From: [Joel Geier](#)
To: [Coffin Butte Landfill Appeals](#)
Subject: LU-24-027 Arsenic issues
Date: Monday, October 20, 2025 3:51:21 PM
Attachments: [Arsenic Simple Scoping Calculation 2025-10-20.pdf](#)

Simple calculations of potential arsenic leaching from Coffin Butte basalt

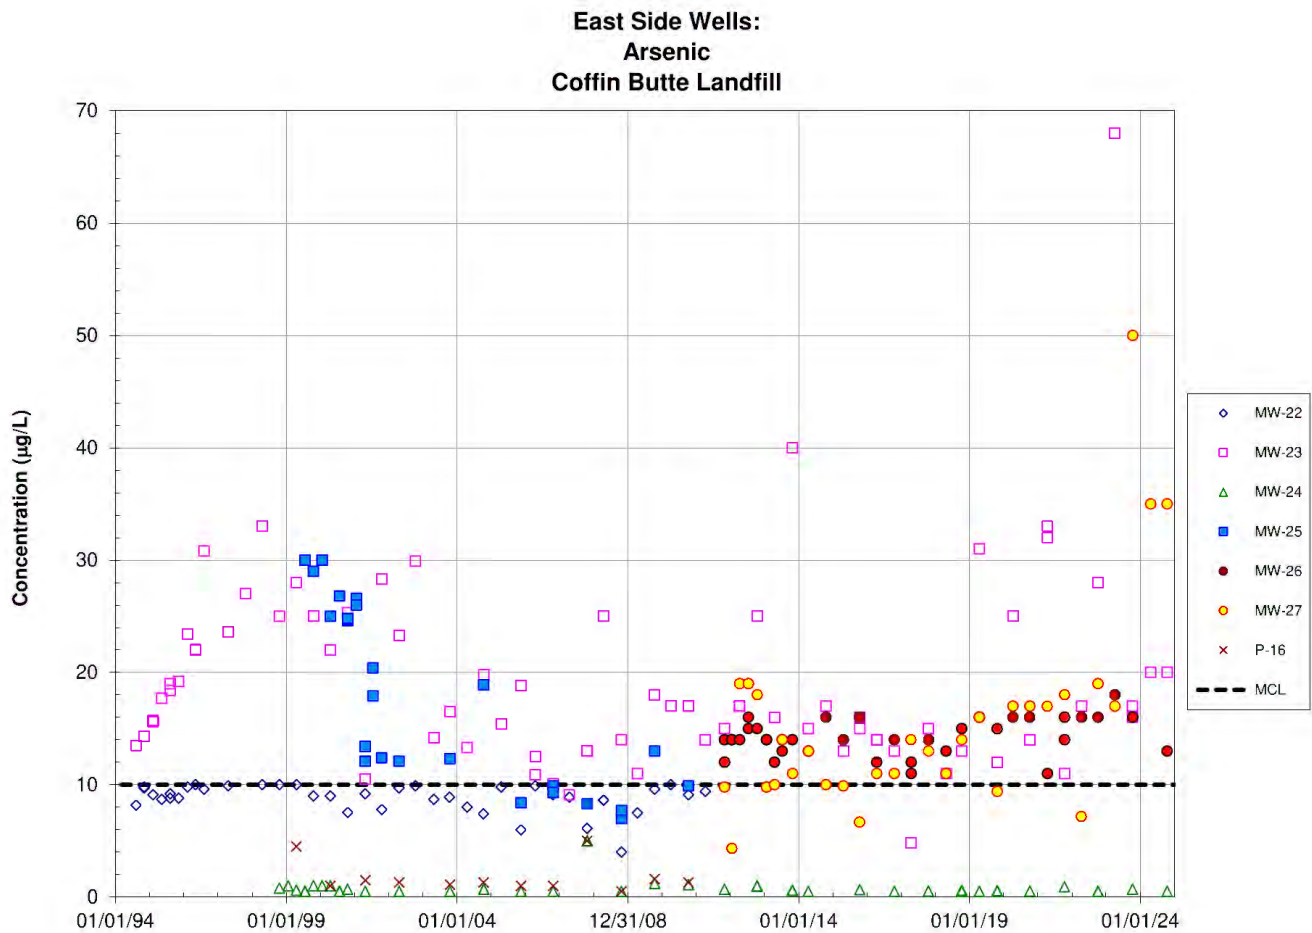
The arsenic concentration in wells along the east side of the landfill, in areas where groundwater is interpreted as discharging from under the landfill⁷, has ranged from around 10 micrograms per liter ($\mu\text{g/L}$) to as high as 68 $\mu\text{g/L}$ in 2023, as shown in **Figure 1**. For the purpose of this simple calculation, 15 $\mu\text{g/L}$ = 0.015 mg/L is a reasonable average for the 30-year period.

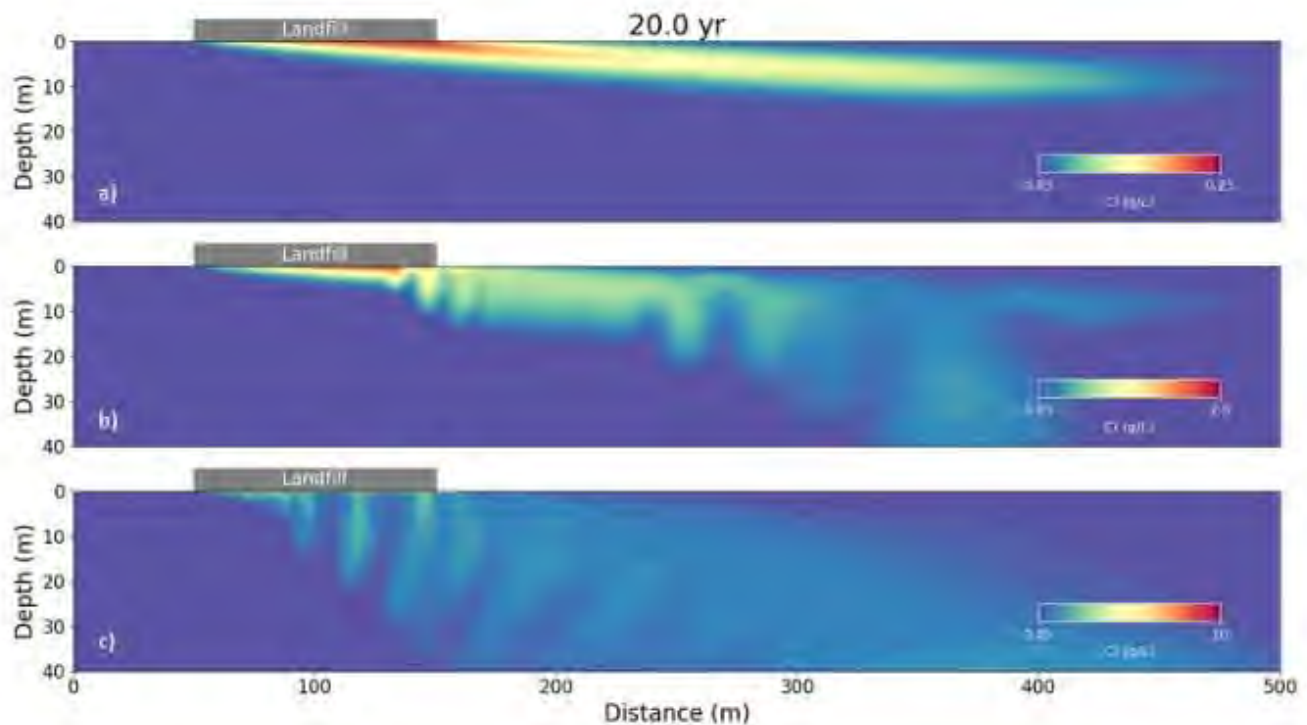
Landfill leachate is also denser than meteoric water (water from rain or snow), due to high concentrations of dissolved solids. Leachate samples from the ponds leachate at Coffin Butte have TDS (total dissolved solids) concentrations as high as 2400 milligrams per liter (mg/L).¹¹ Although the density contrast is small, it can be enough to cause a leachate plume to angle downward from a landfill, as shown by the modeling results in Figure 2. Note that the TDS concentrations in Coffin Butte leachate are comparable to the middle plot (b) in this figure, which exhibits complex dispersion (plume spreading) behavior. When combined with the insufficient depths of MW-26 and MW-27, density effects may increase the

likelihood that the main plume of mobile ions such as chloride could "submarine" below these wells.

Overall, the issues are complex and the remaining scientific questions cannot be fully answered with the available data. **If the applicant is motivated to help to resolve these issues, they could install deeper and additional east-side monitoring wells, in response to the recommendations of the DSAC subcommittee.**
